Subject: Braidwood Station Units 1 and 2
Byron Station Units 1 and 2
Dresden Station Units 2, and 3
LaSalle County Station Units 1 and 2
Quad Cities Station Units 1 and 2
Zion Station Units 1 and 2

Supplement to: Commonwealth Edison Submittal of Information
Pertaining to Motor Operated Valve Testing as Specified in NRC
Generic Letter 89-10 and the Subsequent Supplements to the
Generic Letter

Attachment 1: MPR Associates Letter to Paul Dietz dated December 6, 1994,
"Review of White Paper WP-129, "MOV Design Margin
Evaluation and Diagnostic Test Feedback Evaluation""

**REVIEW REPORT
FOR REVIEW OF COMMONWEALTH EDISON WP-129**

Figure 1. MOV Design Margin Calculations

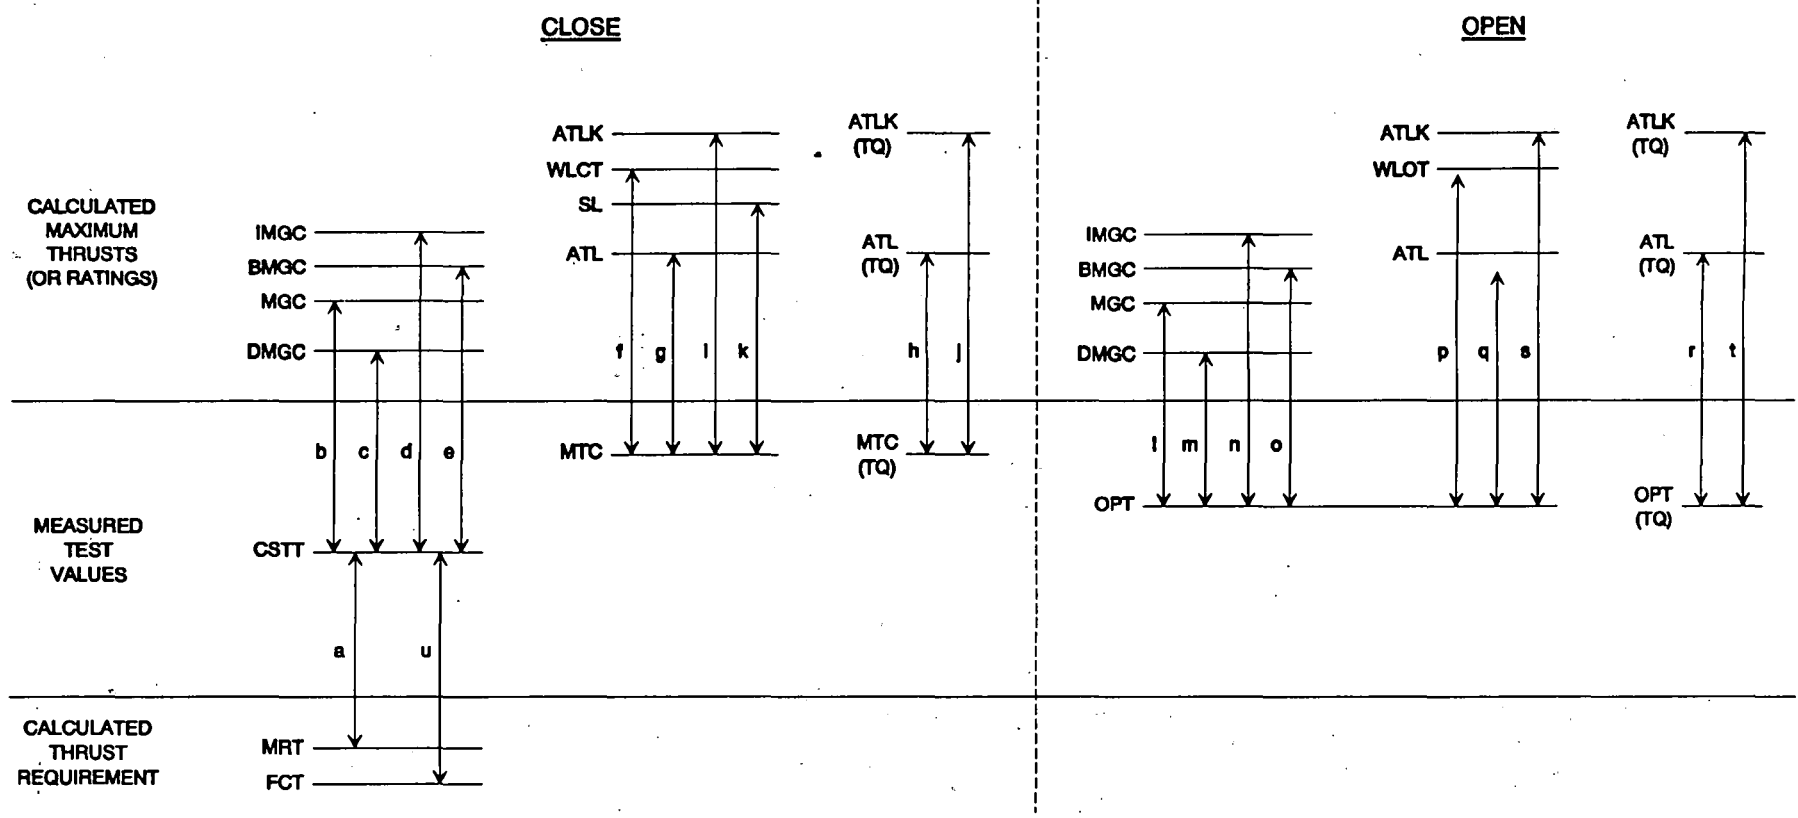
- There are a total of twenty-one different design margin calculations identified in WP-129 (Section 4, items 4a through 4u). It is not clearly stated whether all of these twenty-one calculated design margin values need to satisfy specific criteria for the design margin to be acceptable, or whether (in some cases) only some of the calculated margin values need to meet criteria. The position needs to be clarified.

Figure 1 of this review report illustrates the twenty-one different design margin calculations identified in WP-129. A diagram similar to Figure 1 should be included in the white paper to more clearly illustrate the set of design margin calculations described.
